Technical Service Information

THM 4L80-E CENTER GEAR BOX CHANGES FOR 1999 MODELS

Figure 1

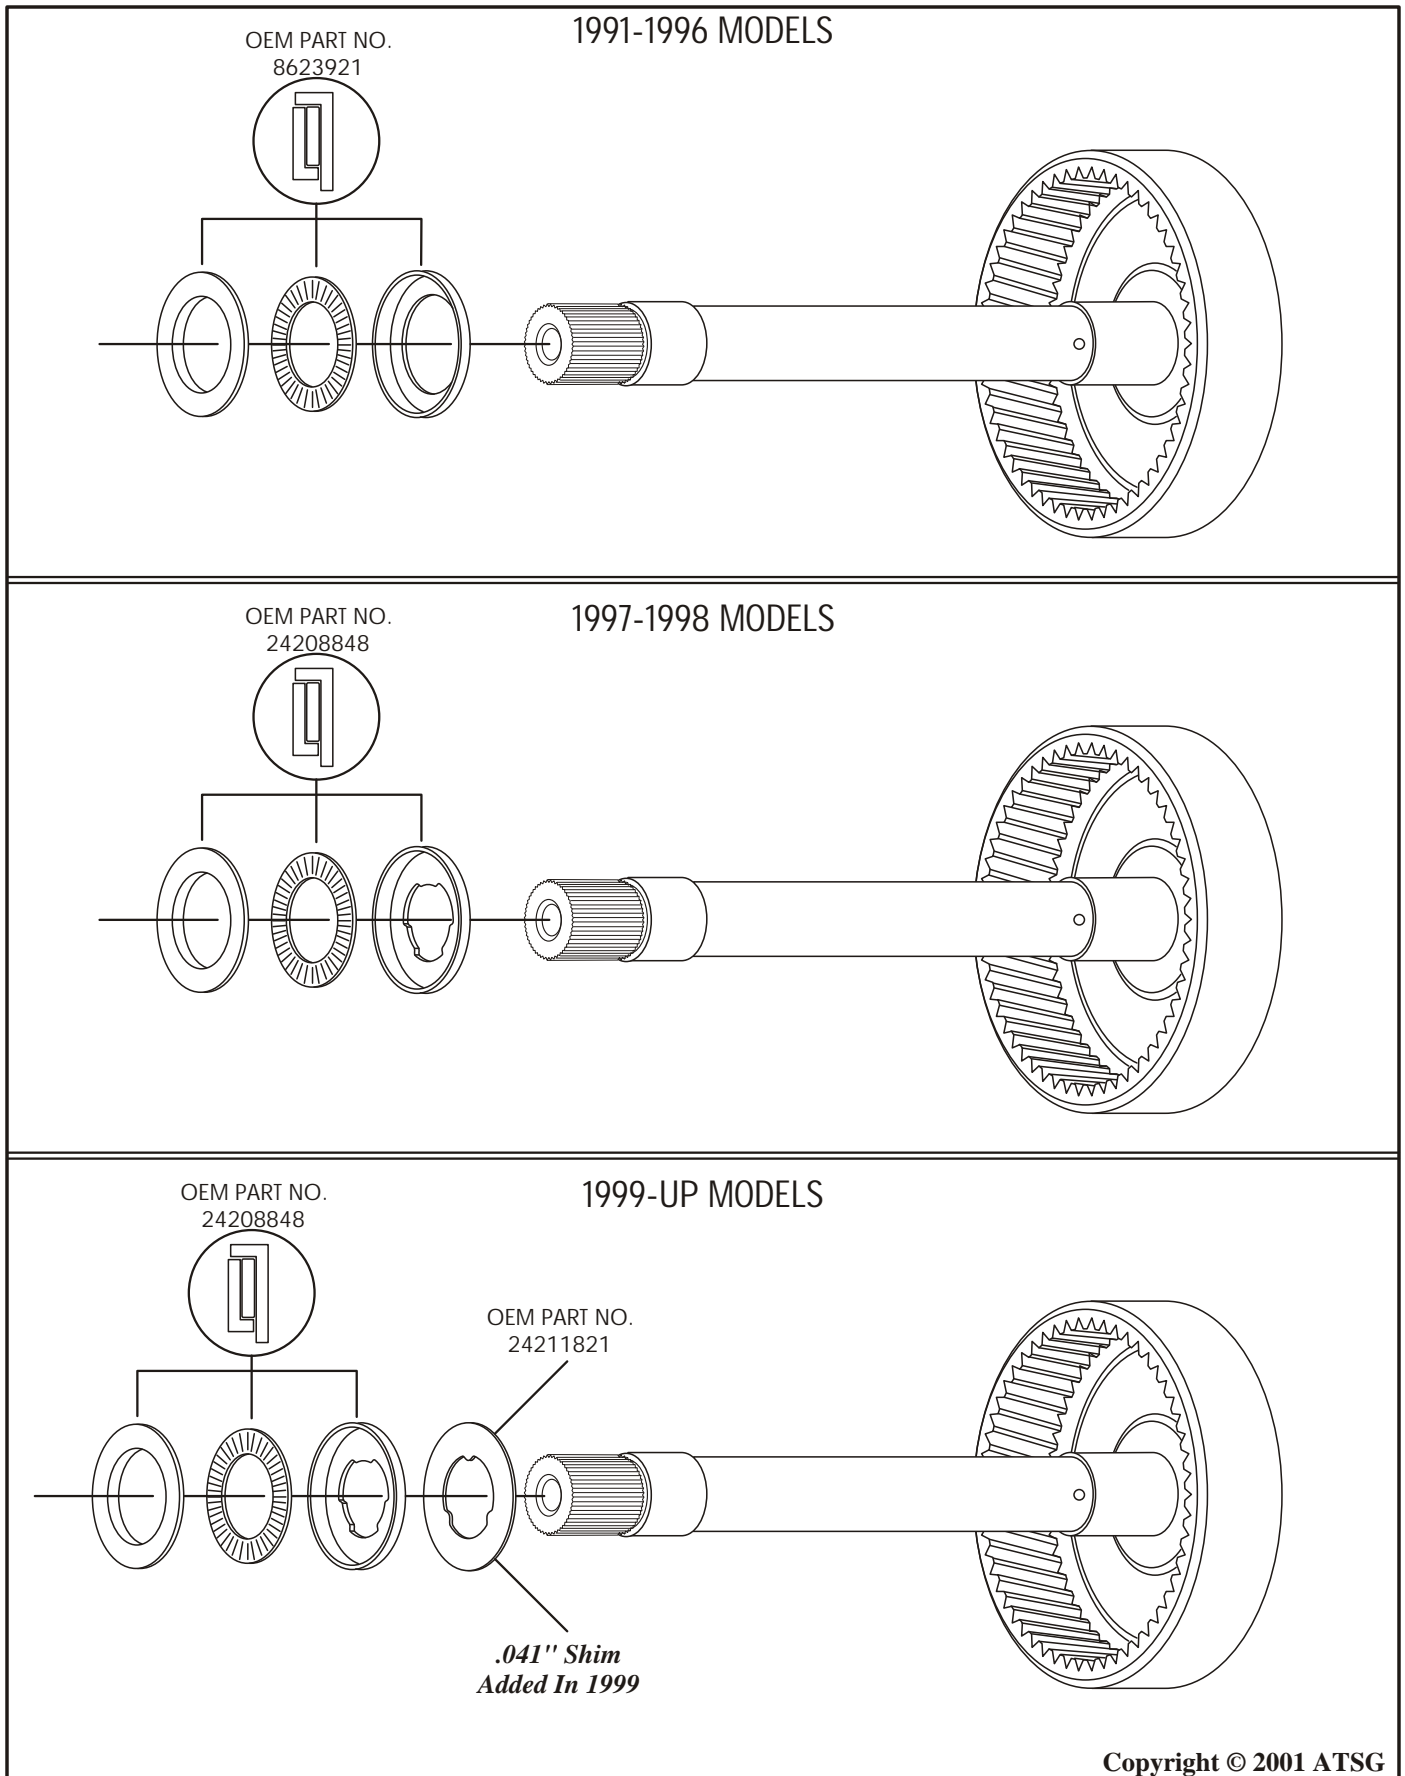
CHANGE: Beginning at the start of production for all 1999 model THM 4L80E transmissions, the planetary pinions on both carriers were produced 10% thicker than the previous models, as shown in Figure 1. This engineering change required the addition of a .041" shim in the gear train to re-center the sun gear in the new planetary pinions and affected several internal parts, that may create some confusion, and thus some mis-assembly concerns.

- (1) PLANETARY PINION GEARS - Were increased in length by approximately .075" in both front and rear carriers, as shown in Figure 1, for increased durability.
- (2) ADDED .041" SHIM - There was a .041" shim added between the thrust bearing and the rear internal ring gear, to re-center the sun gear in the revised planetary pinion gears, as shown in Figure 2.
- (3) CENTER SUPPORT - Required a .041" recess to be machined into the center support bearing surface, to accommodate the sun gear being re-centered in the revised planetary pinion gears, as shown in Figure 3.
- (4) SUN GEAR SHAFT - Required that .041" be removed from the bottom of the rear bushing journal, to accommodate the re-centering of the sun gear in the revised planetary pinion gears, as shown in Figure 4. Notice that revised sun gear shaft can be identified with a groove cut into the shaft splines, as shown in Figure 4.

Figure 8

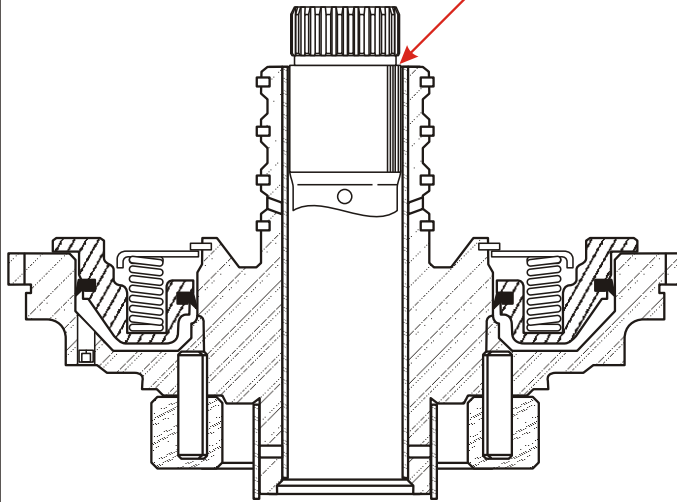
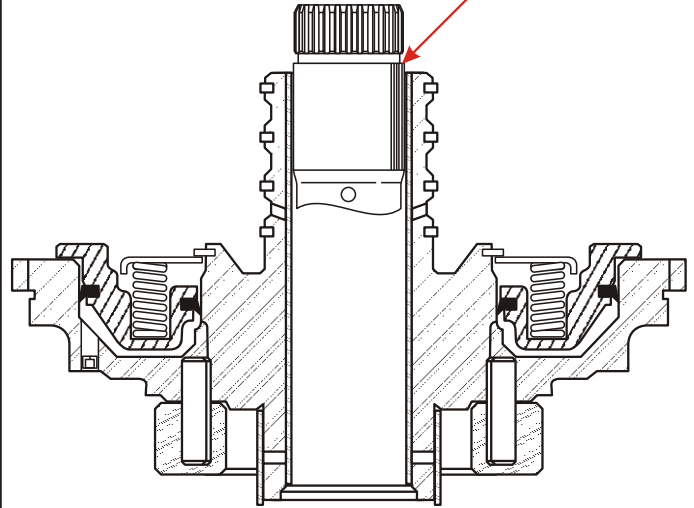
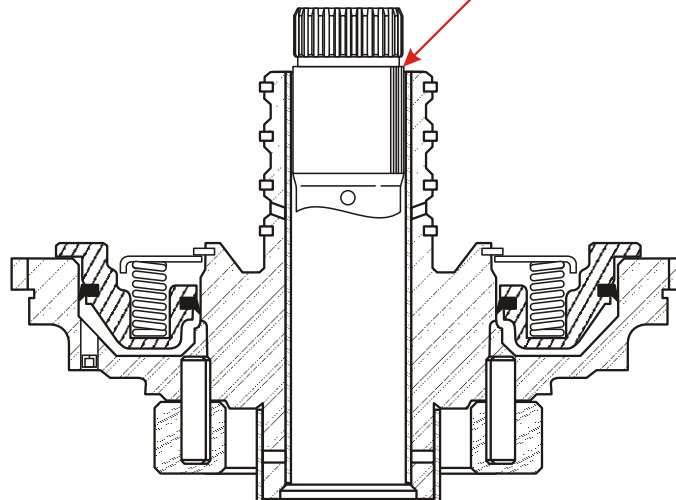
SPECIAL NOTE: Some mis-assembly examples are illustrated in Figure 8 with some dimensional checks to prevent this from happening to you.

1999 SUN GEAR SHAFT
WITH 1997-98 CENTER SUPPORT
AND NO .041" SHIM

*Shaft Journal
Approximately
Flush With Support*

1997-98 SUN GEAR SHAFT
WITH 1999 CENTER SUPPORT
AND WITH .041" SHIM

*Shaft Journal
Approximately
.090" Above Support*

"CORRECT ASSEMBLY"
WITH PROPER
SUN GEAR SHAFT
AND CENTER SUPPORT

*Shaft Journal
Approximately
.050" Above Support*
